## CITY OF FITCHBURG

### NOTICE PLAN COMMISSION July 21, 2015

### NOTICE PLAN COMMISSION July 21, 2015

**Fahey Fields Plat  
CDP & Preliminary Plat  
Public Works Review #3**

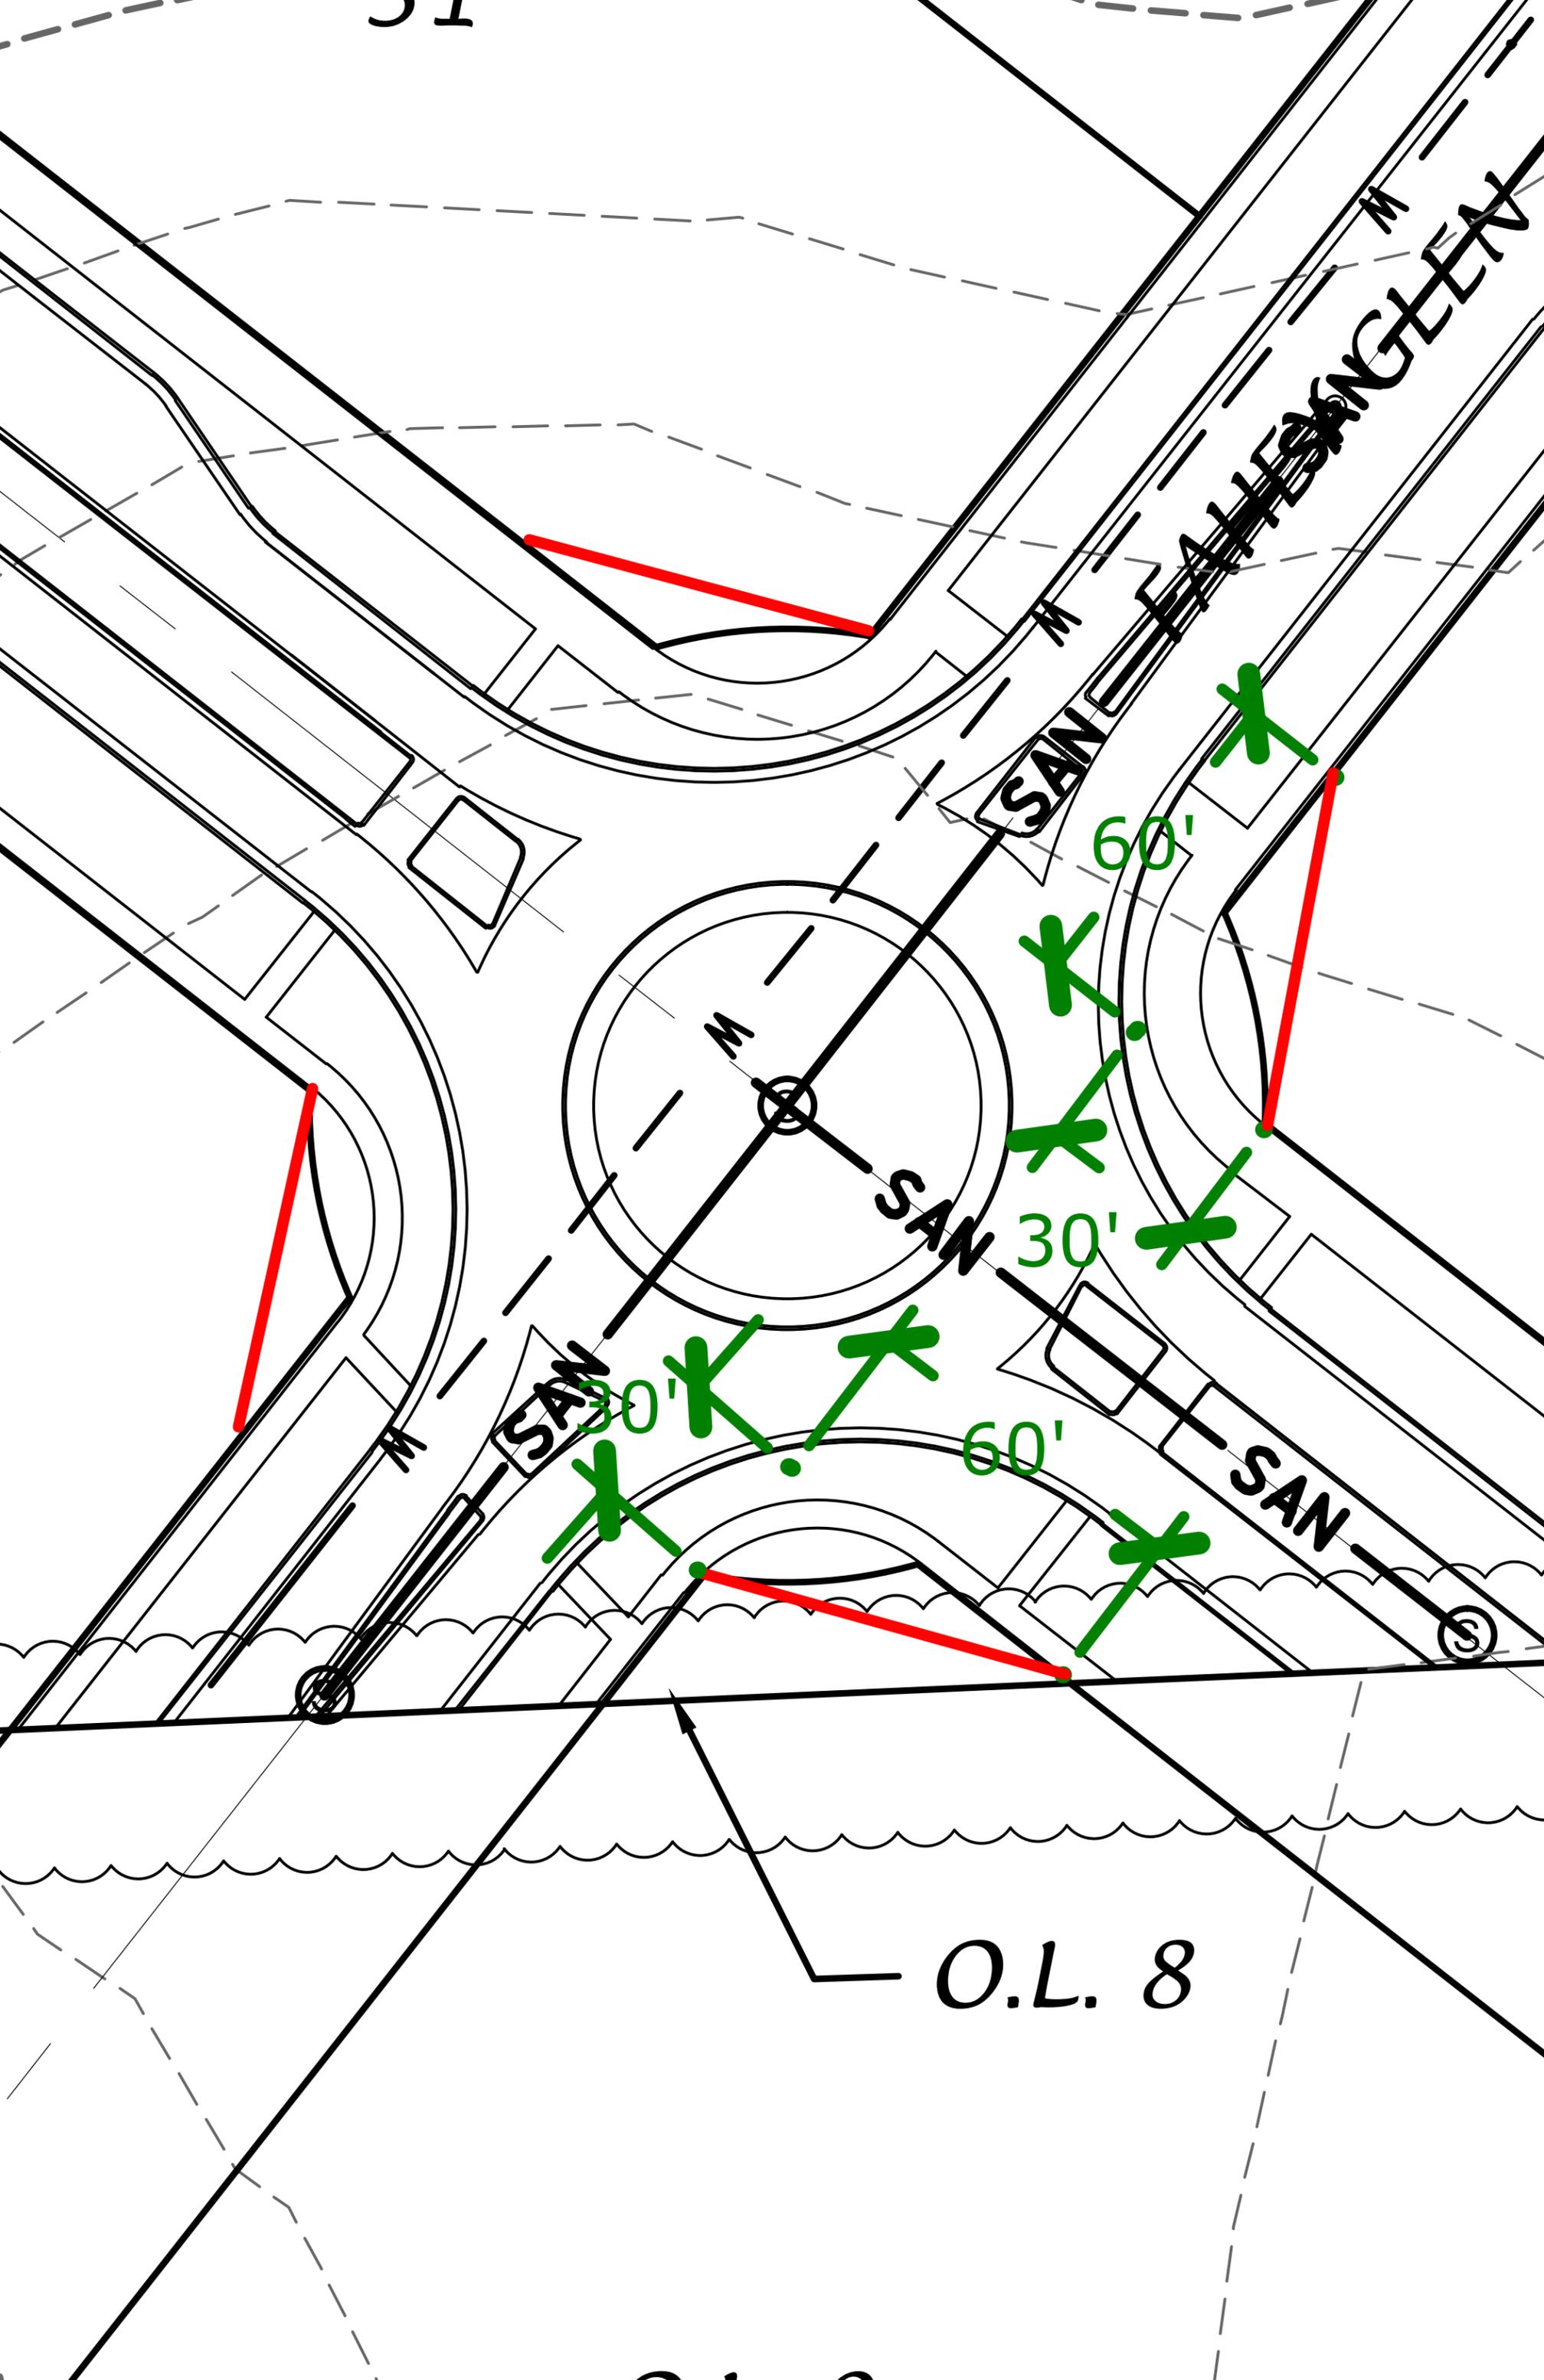
1. CDP 3.2 Proposed Utility Plan - Note 10" sanitary sewer shall be installed on Fahey Glen, from the north plat line to the south plat line, and 8" sanitary sewer shall be installed throughout the remainder of the plat.  
[Applicant Response to PW #2 Comment: Acknowledged.](#)  
[PW #3 Comment: Please make the above change to the CDP.](#)

2. It is strongly recommended that the designer meet with the Fitchburg Utility prior to the start of utility design to discuss requirements and layout.

**A200**

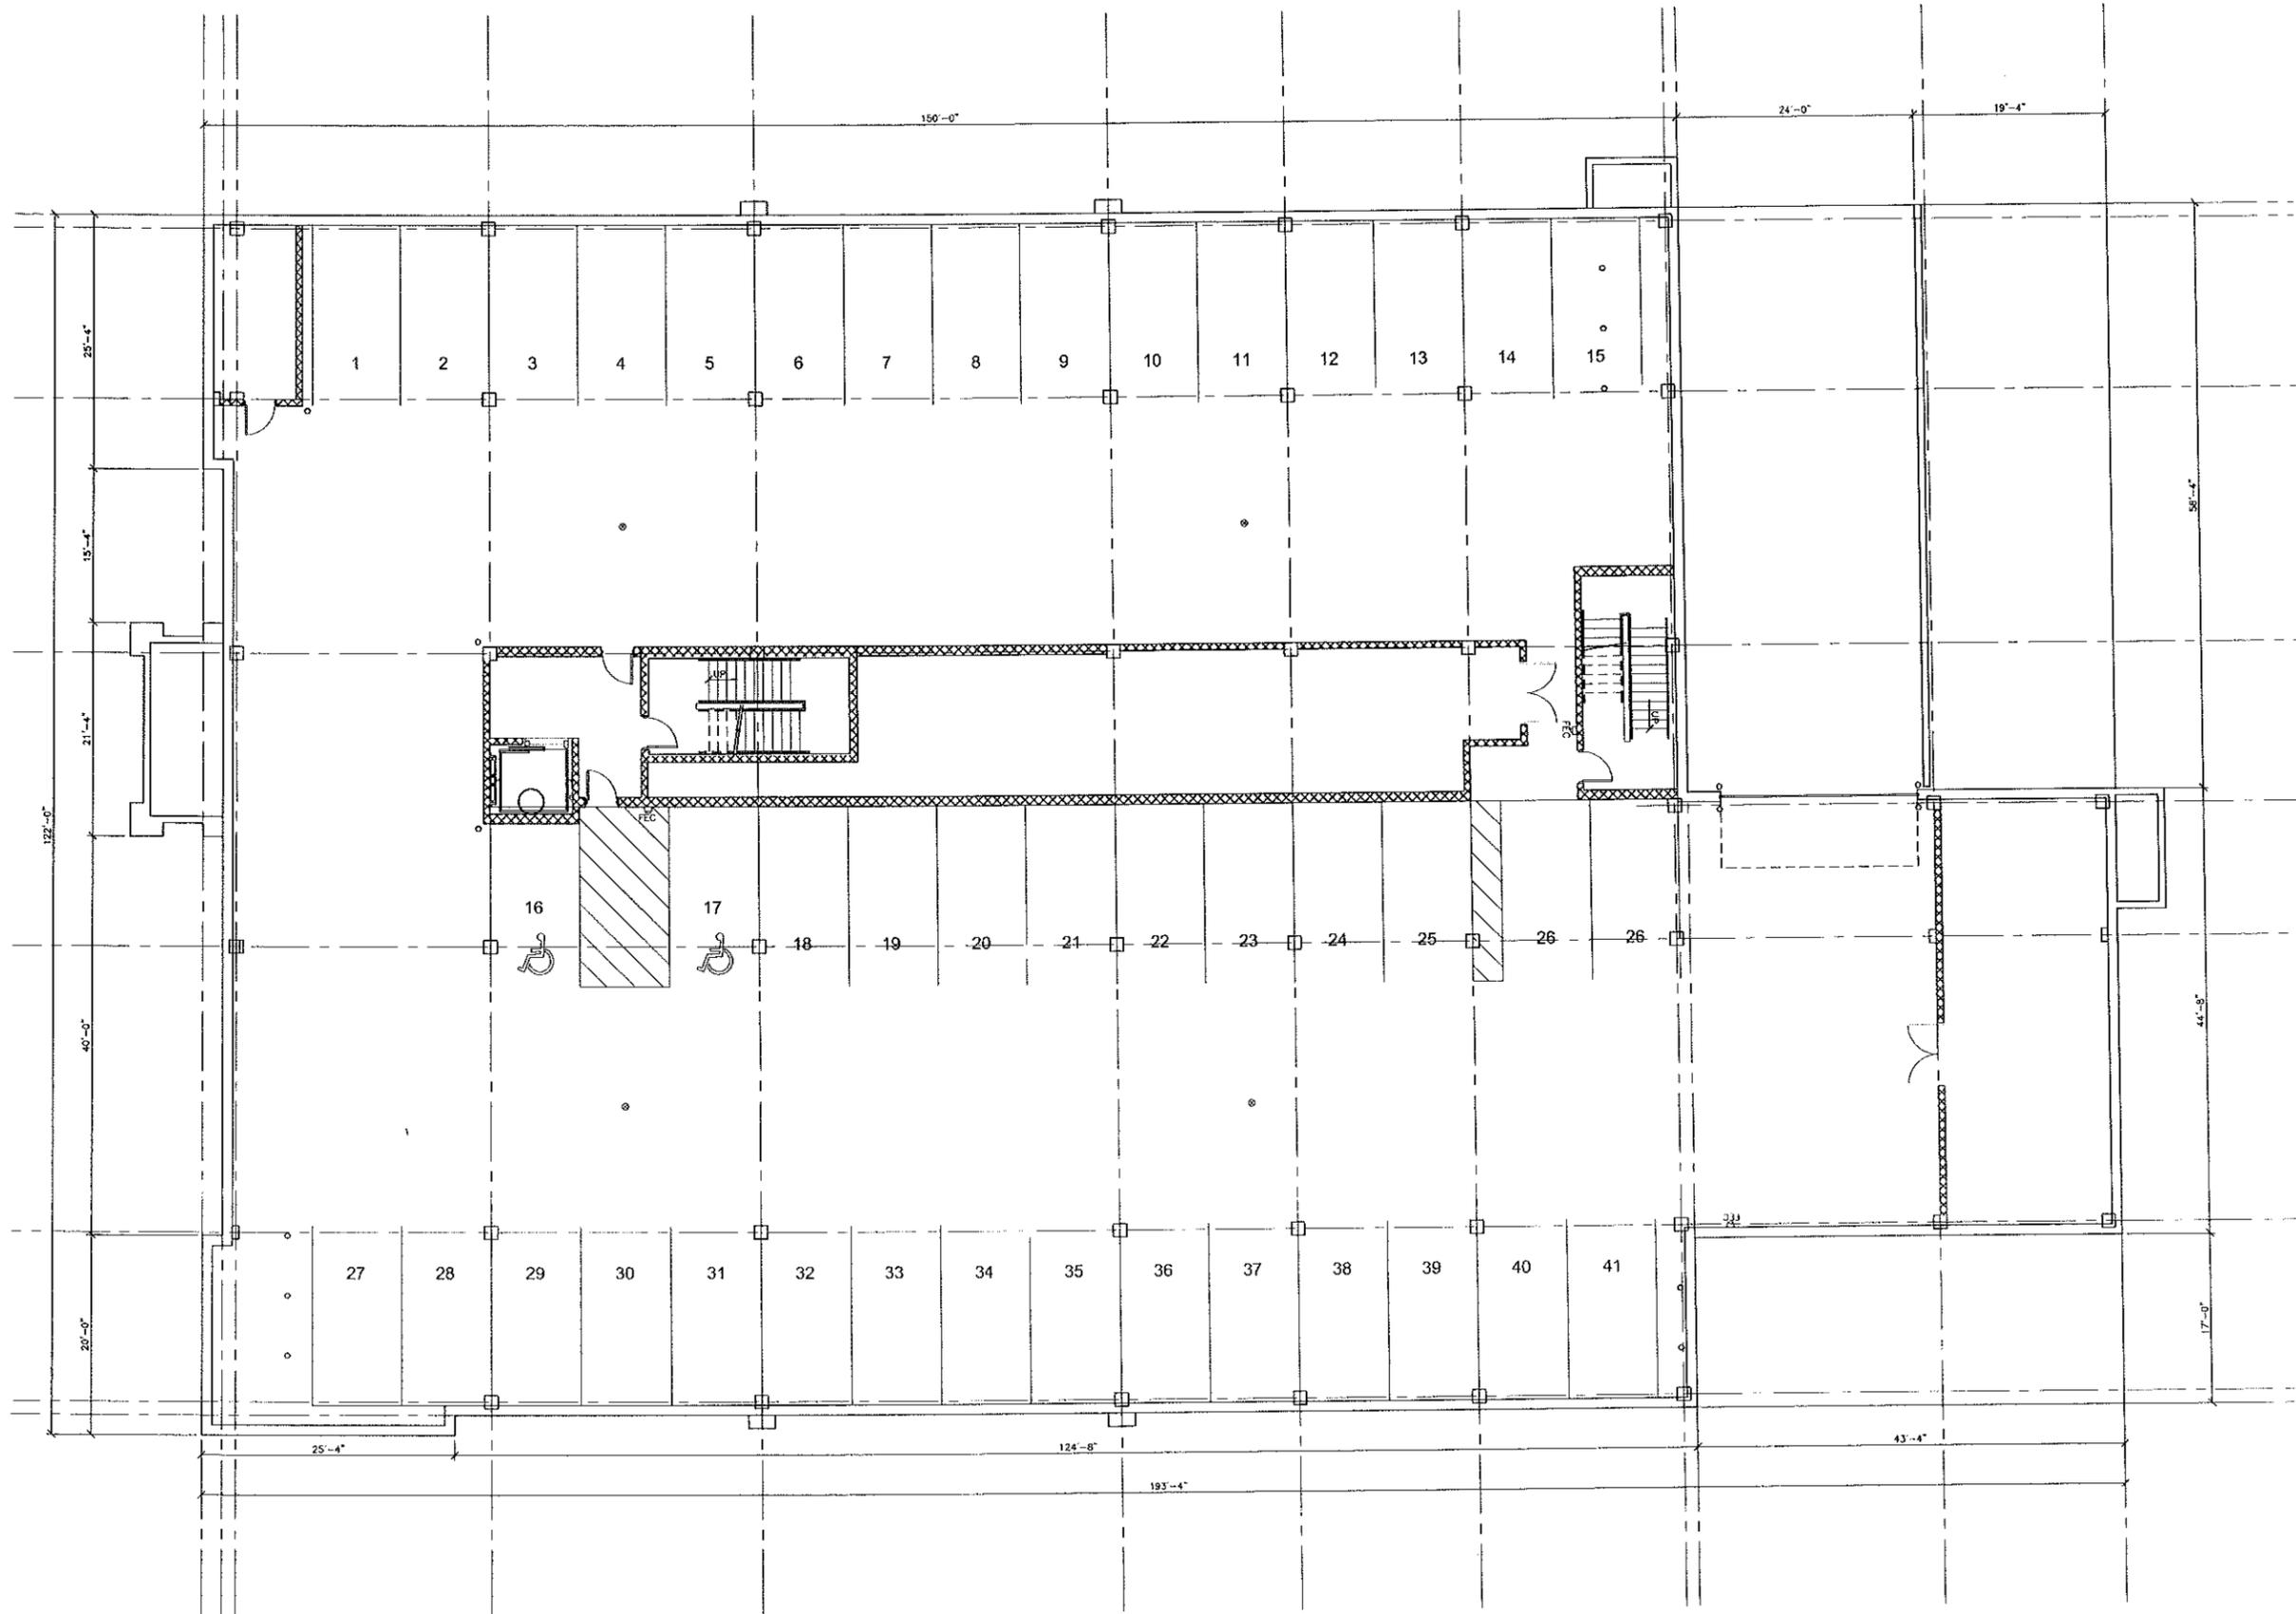
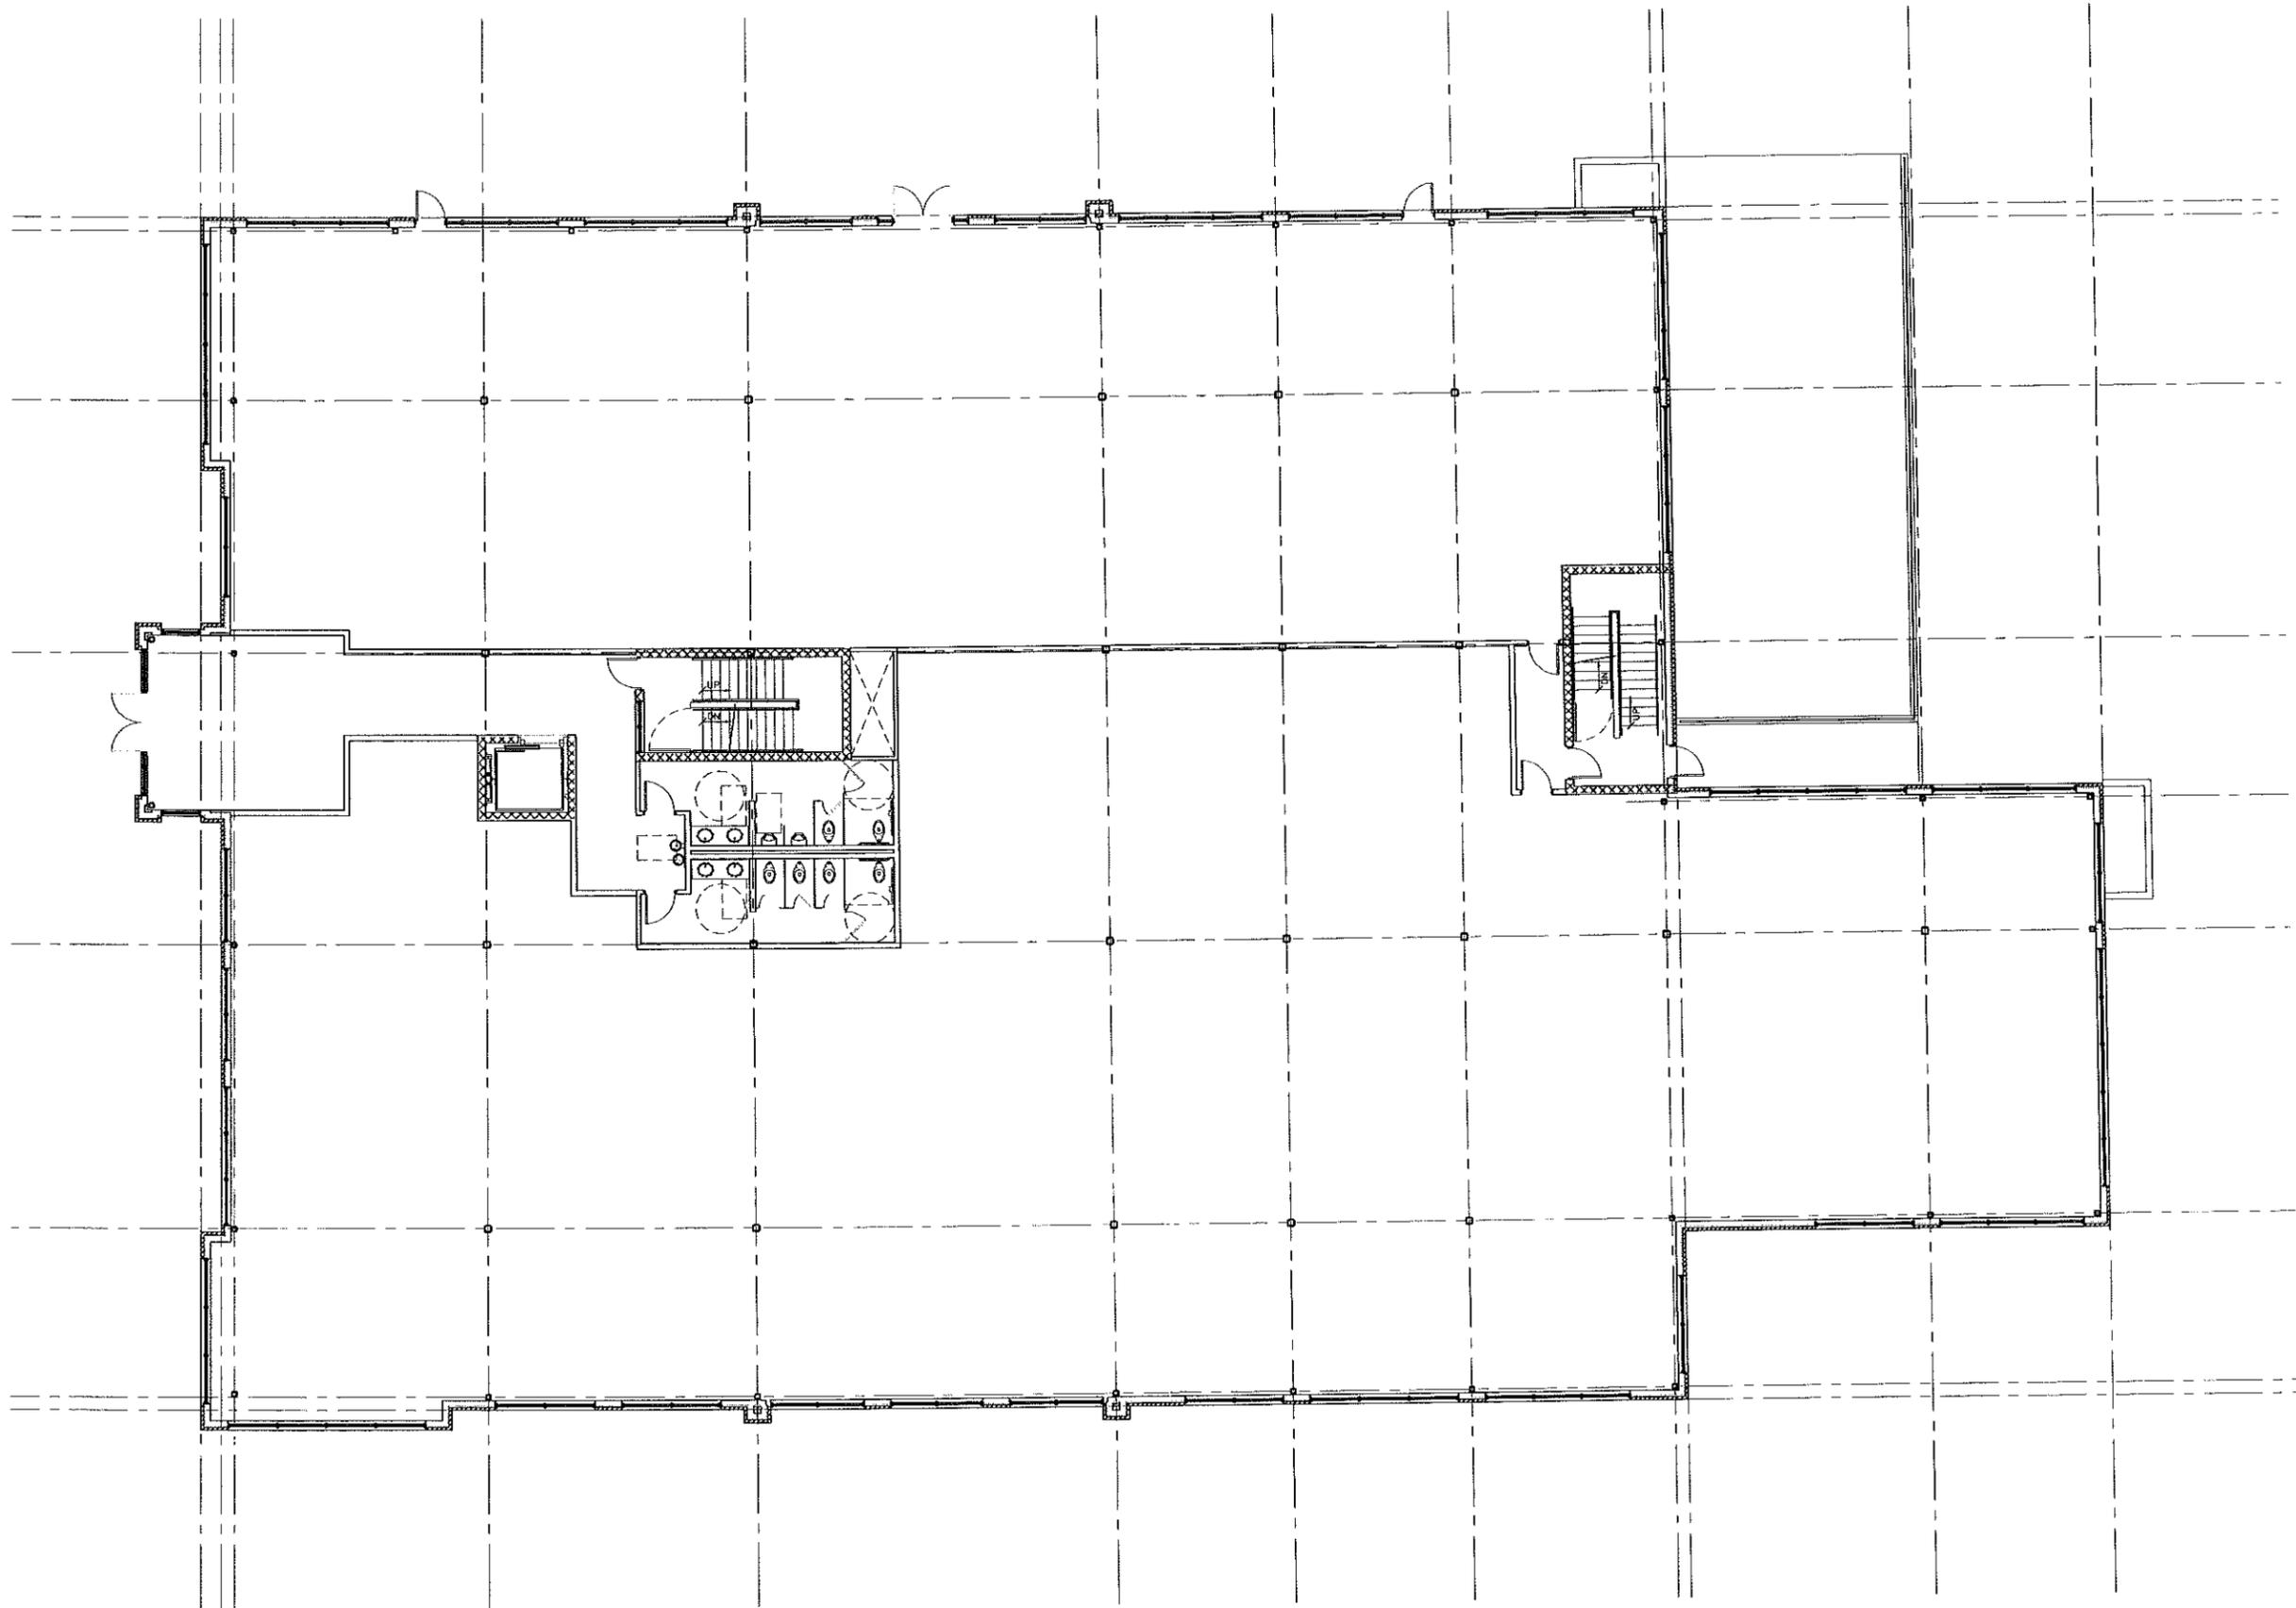
1. Sheet C-1.0 in the site information block has the building total square feet at 20067. Sheet A100 has building footprint at that number. Sheet C-1.0 appears incorrect so please provide the actual total sq ft of the building not just the footprint.

- a. The property lines shown on the plans reflect the removal of all land being turned over to the DOT.
4. Sheet C-1.0 site information block has building at three stories, when it is two, please correct.
